1-20 Colway Street

Summary of changes

Section A: 1-20 Colway Street

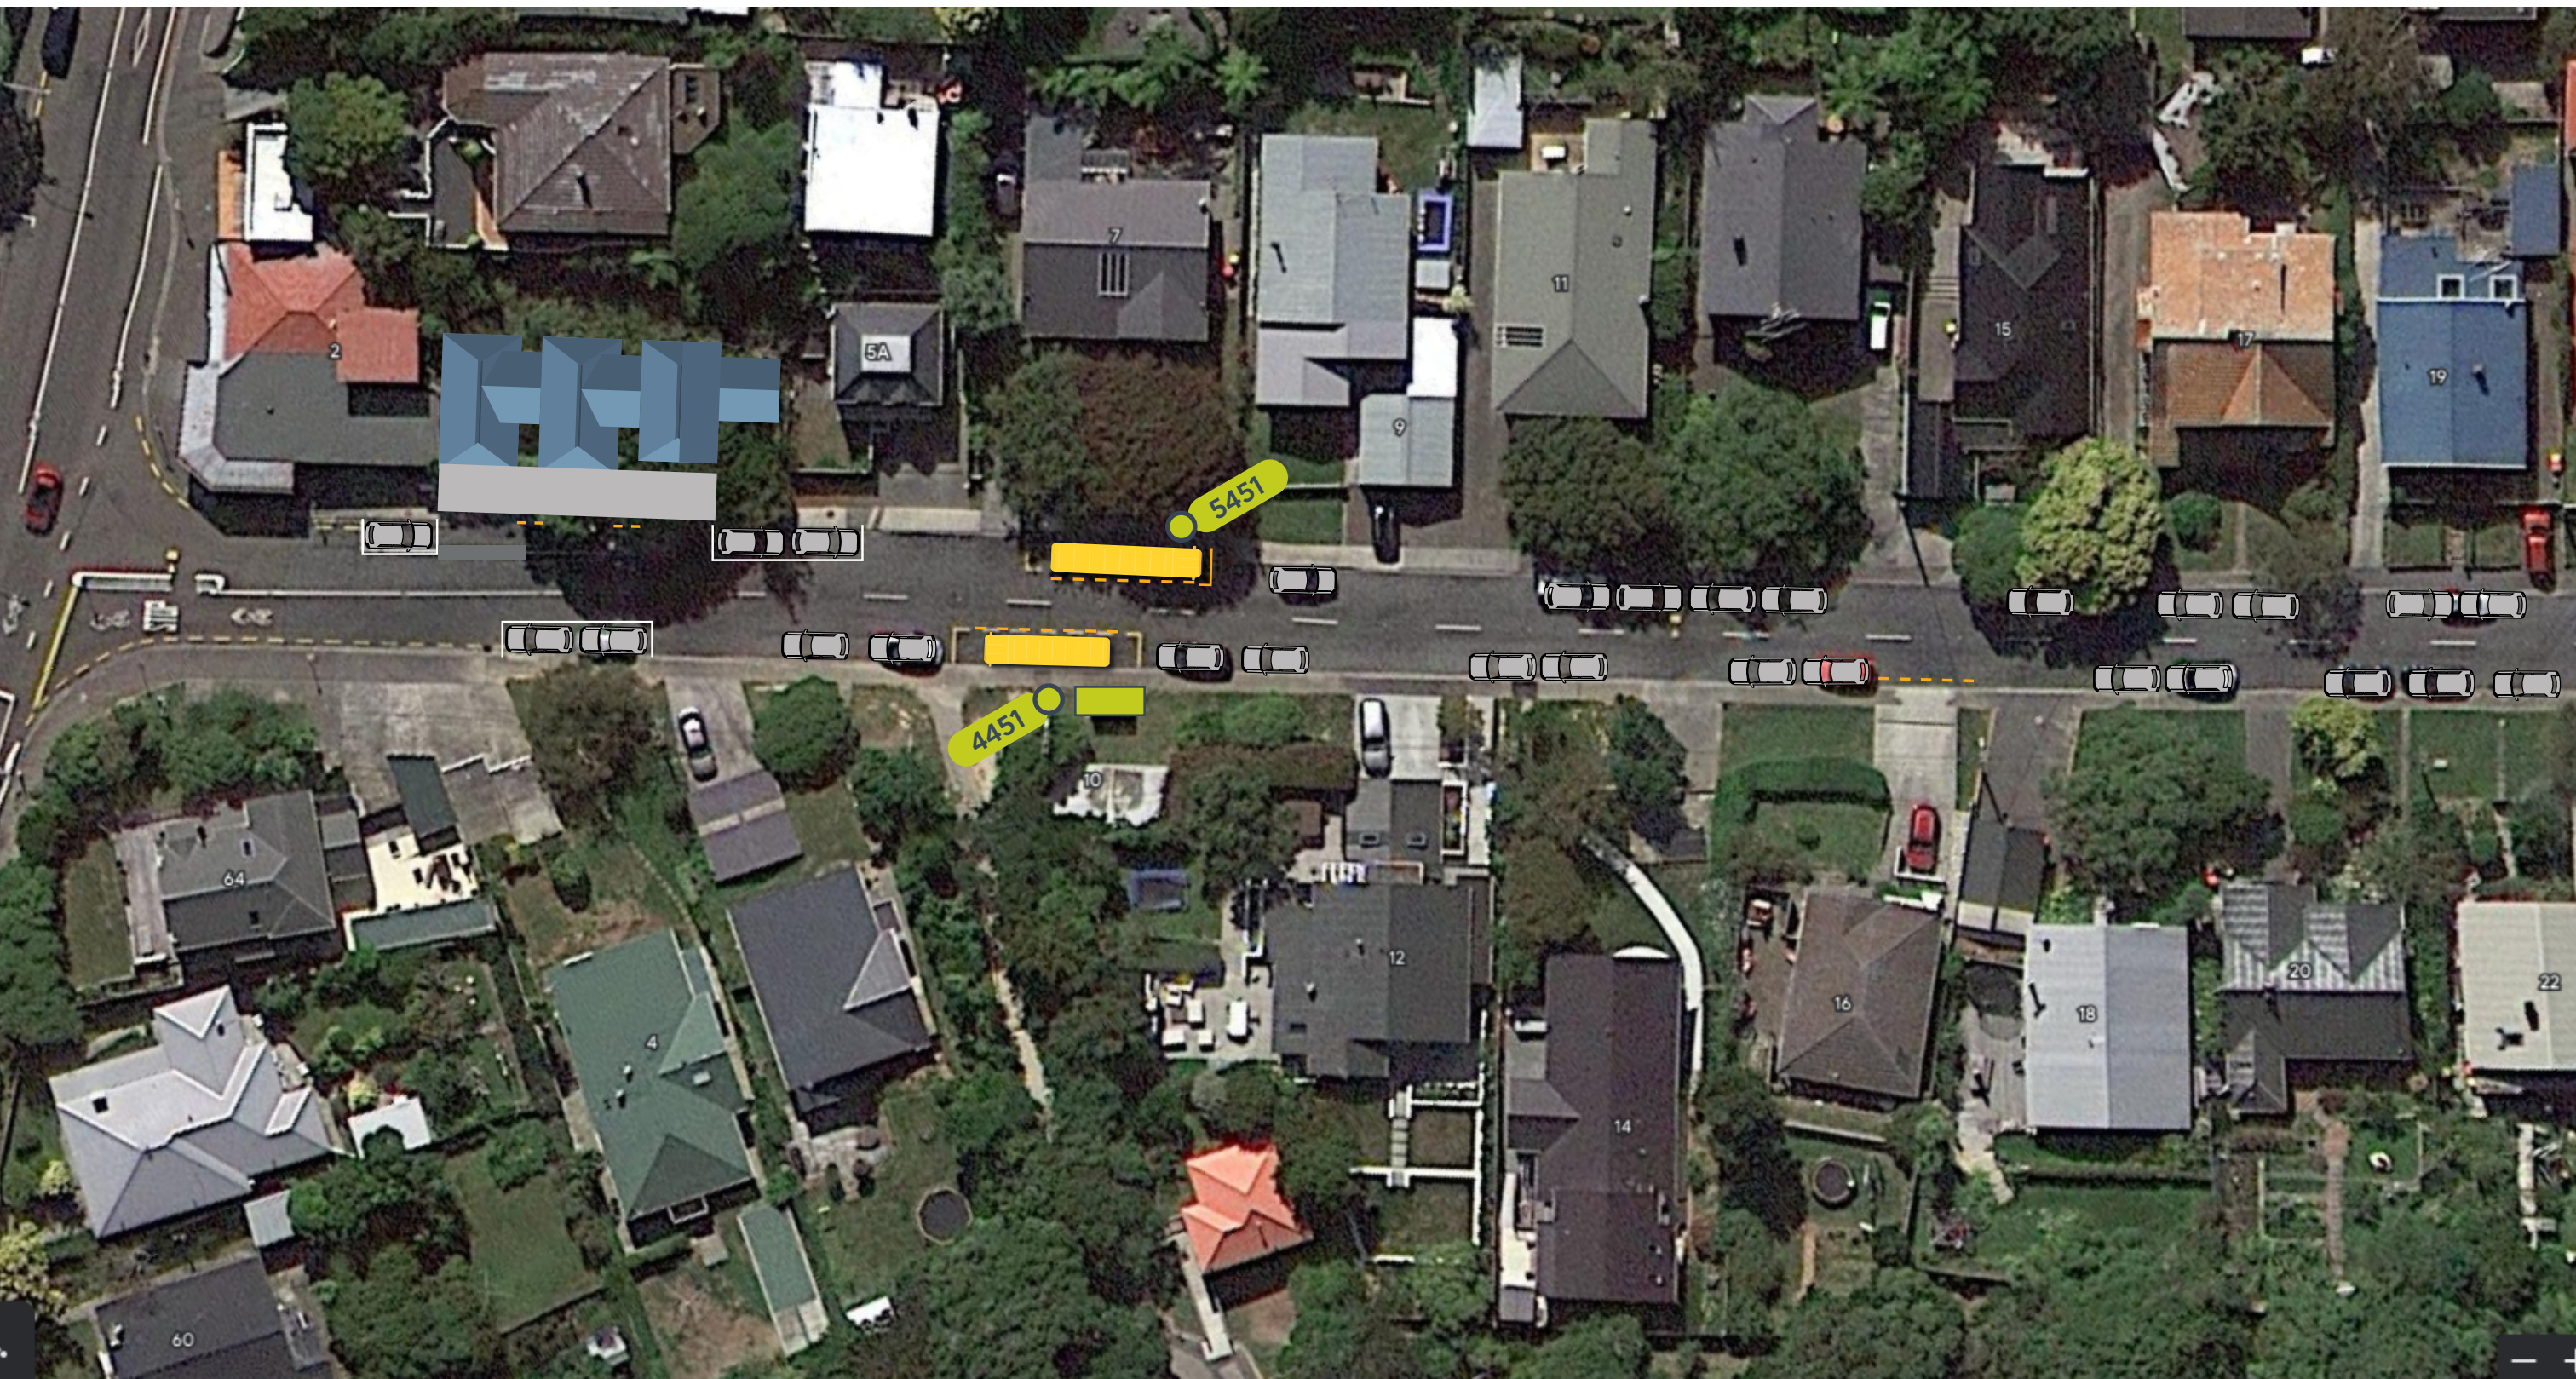
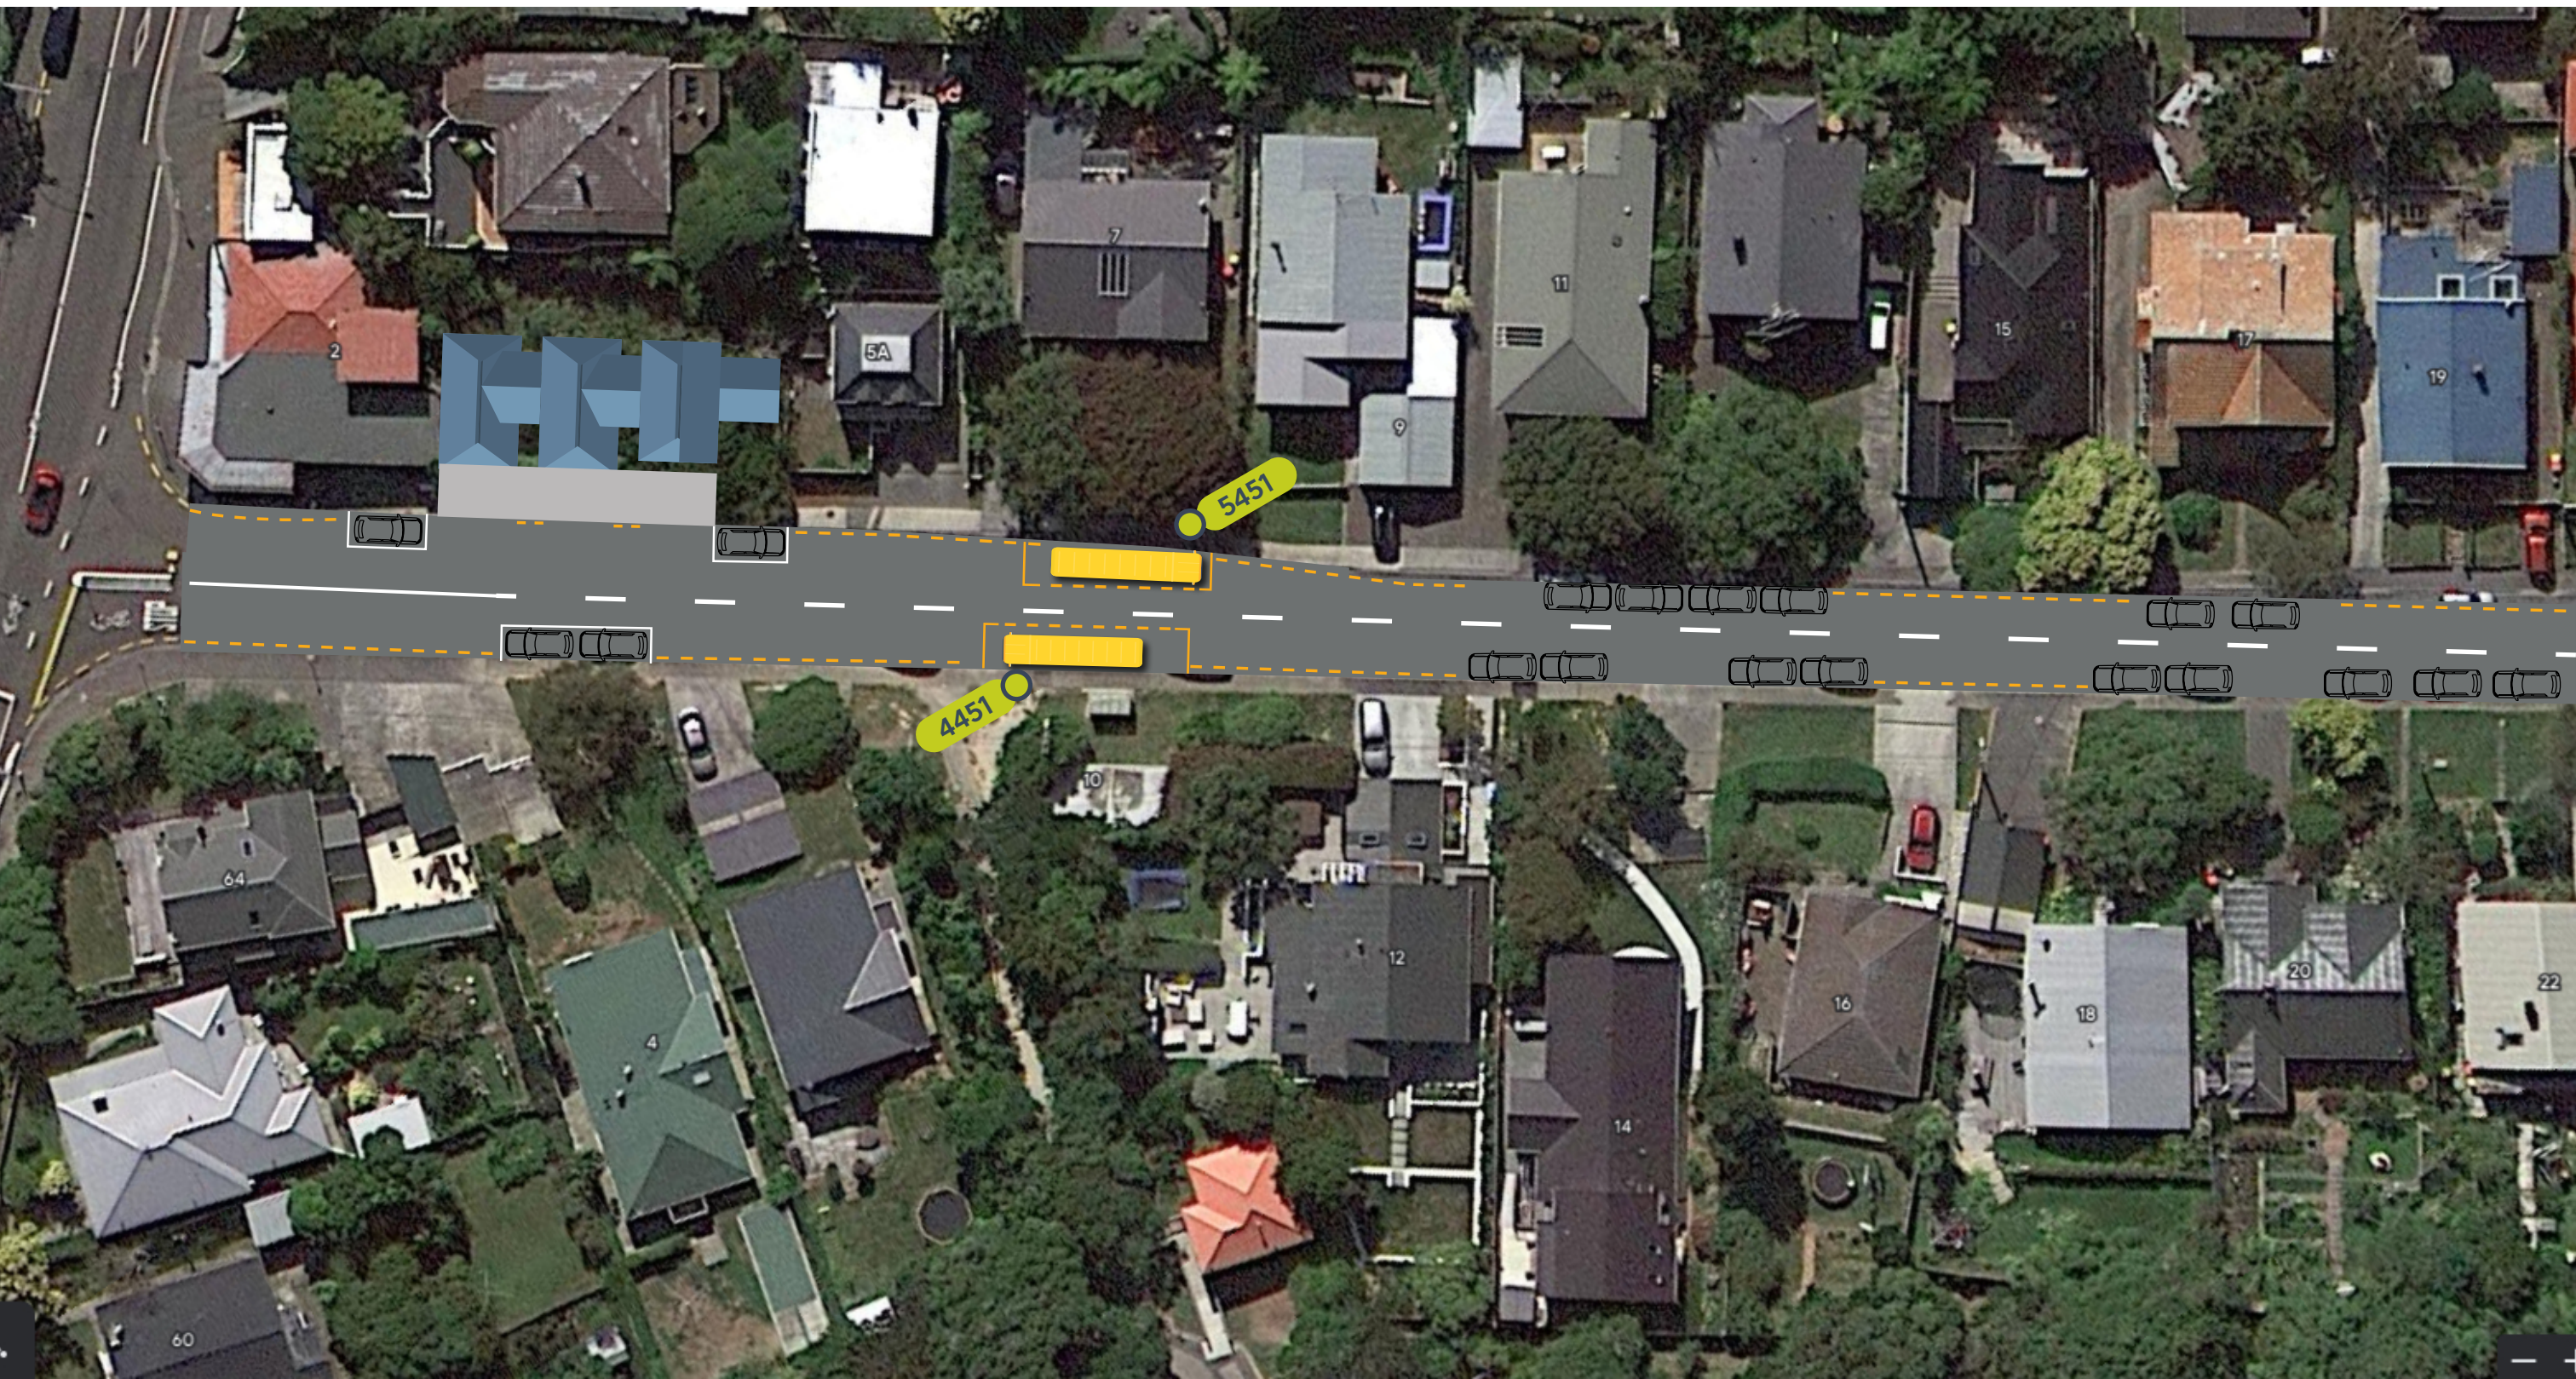
- Stop 4451: extend bus box by 2.7m, add broken yellow lines to create 18.8m entry taper & 20.5m exit taper for buses
- Stop 5451: add broken yellow lines to create 15m entry taper & 15m exit taper for buses
- 15 Colway Street: add 20.2m of broken yellow lines
- 18 Colway Street: add 7.1m of broken yellow lines
- 19 Colway Street: add 16.3m of broken yellow lines

Section C: 43-65 Colway Street

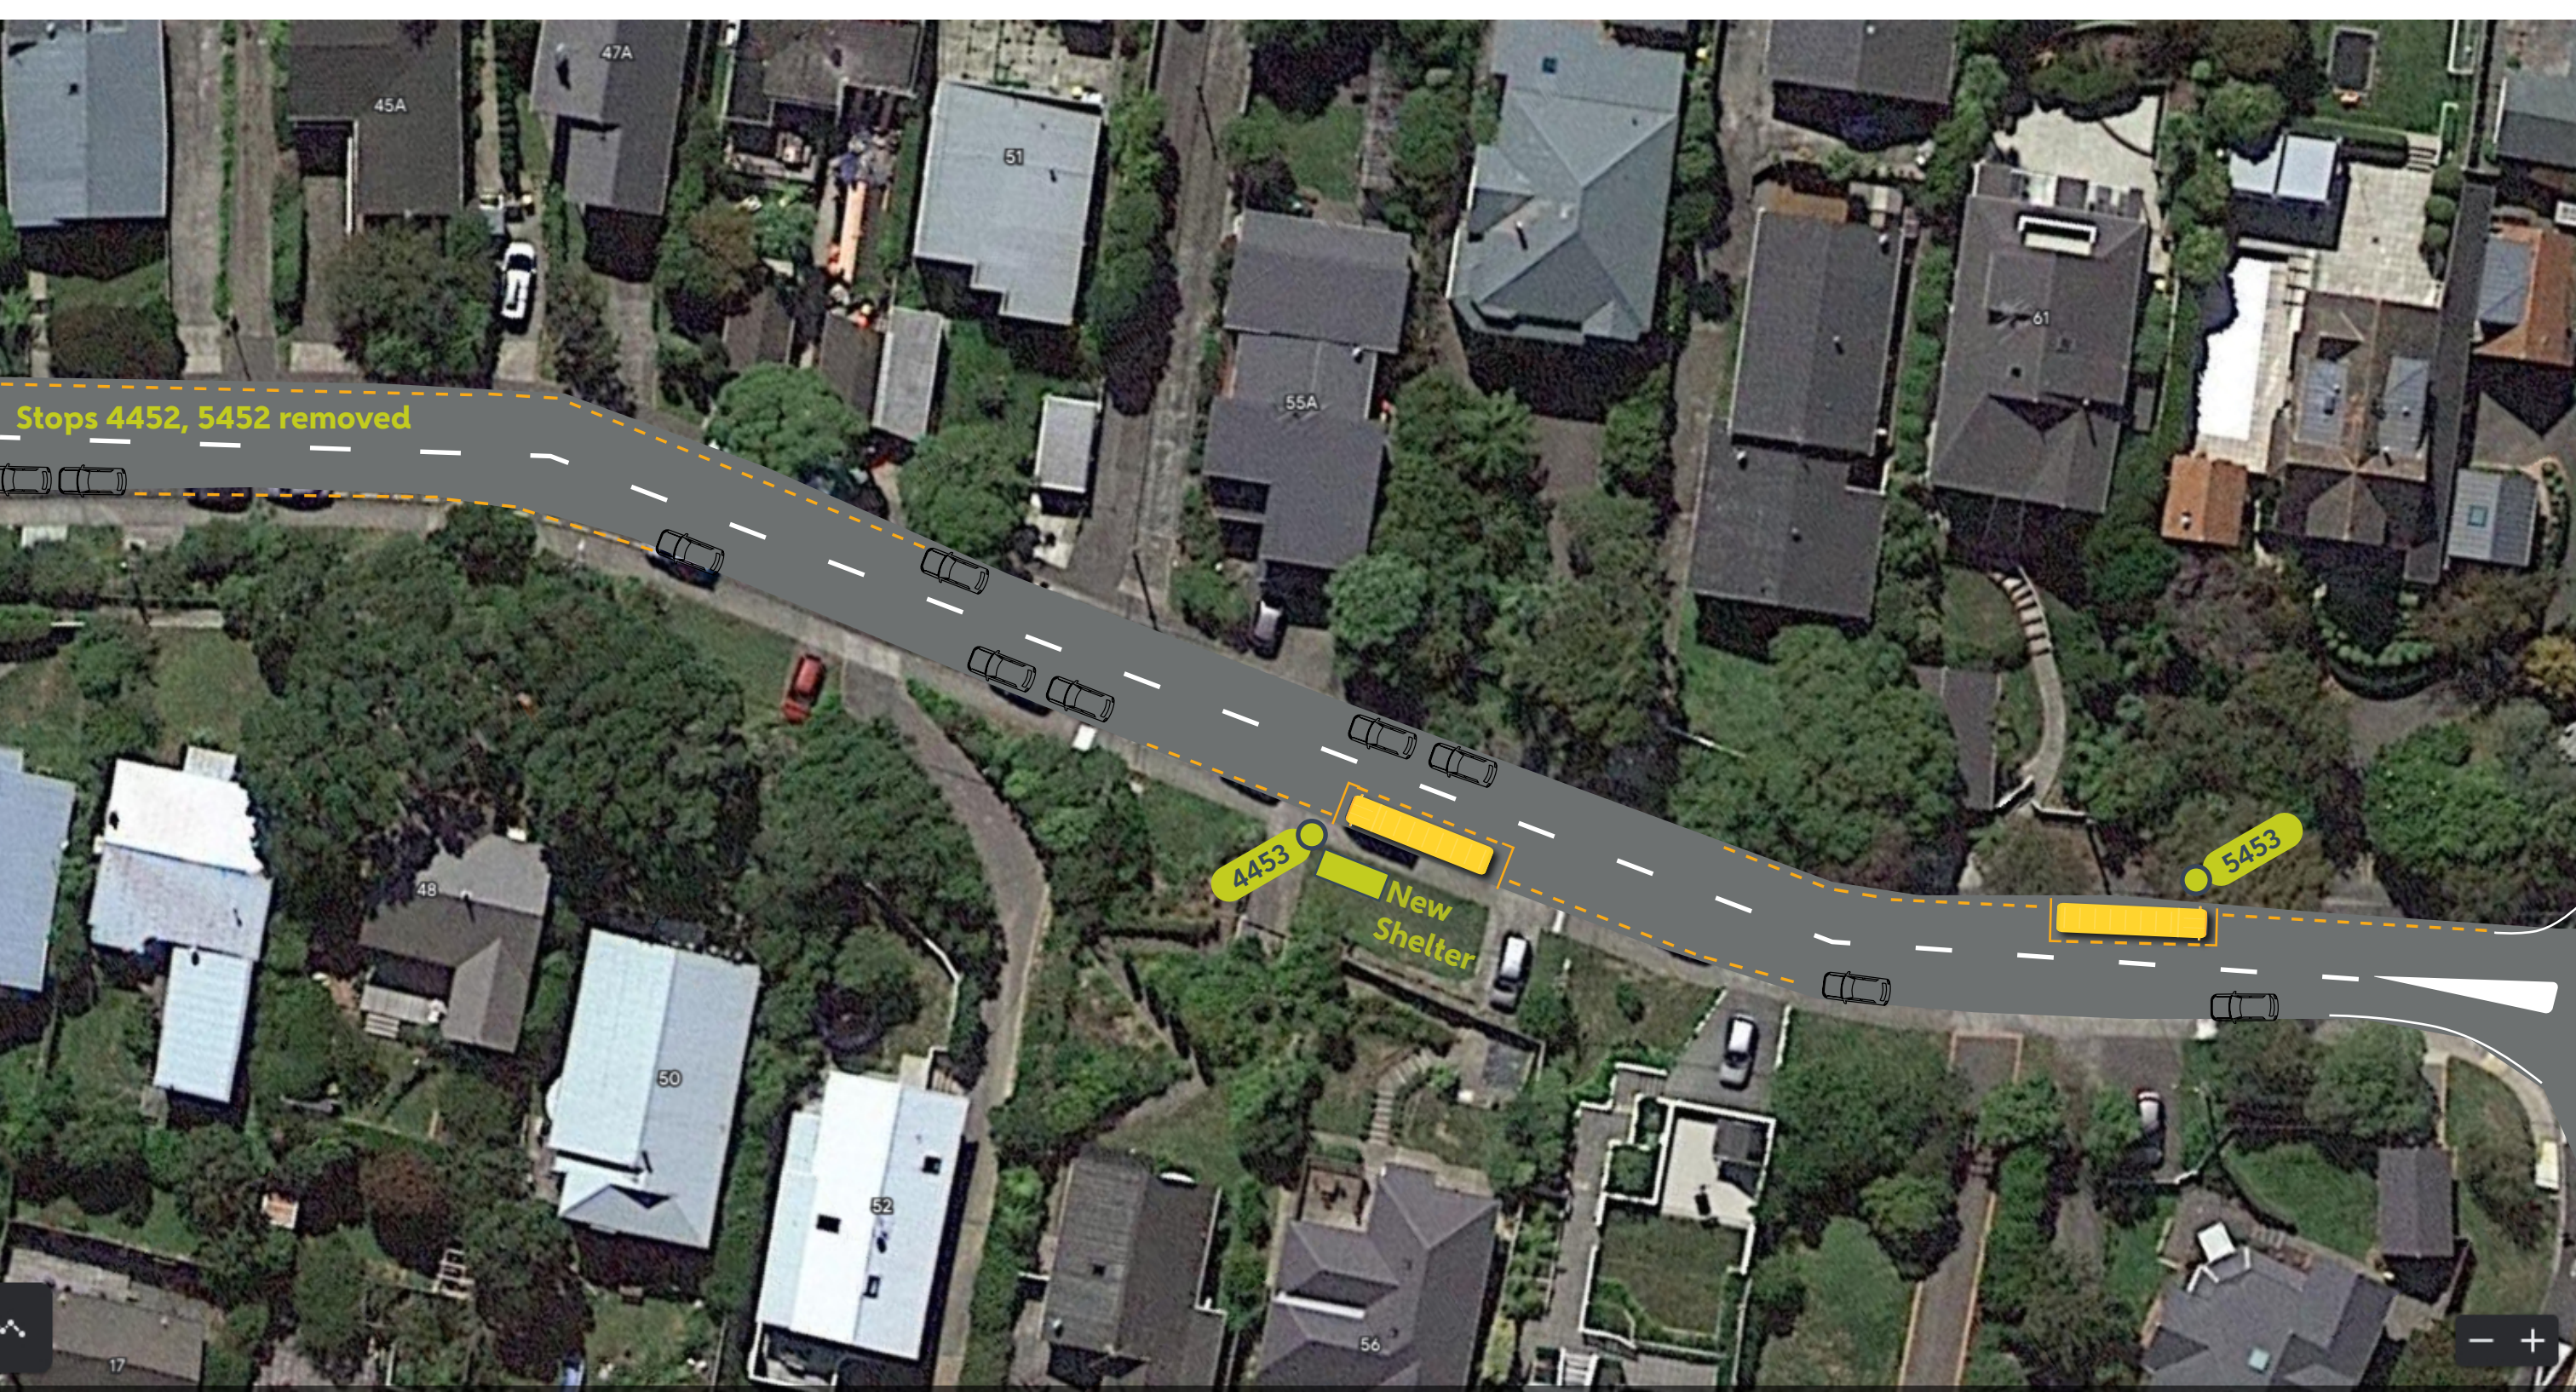
- Stop 4452: remove stop and shelter
- Stop 5452: remove stop
- Stop 4453: move to outside 56 Colway Street, add new shelter, add 15m bus box, add broken yellow lines for 15m entry taper & 9m exit taper for buses.
- Stop 5453: add 15m bus box, add 20.4m entry taper & 15.2m exit taper for buses.
- 43-51 Colway Street: add 67.4m of broken yellow lines
- 46-48 Colway Street: extend broken yellow lines by 10.9m

Stops 4452, 5452 removed

New Shelter
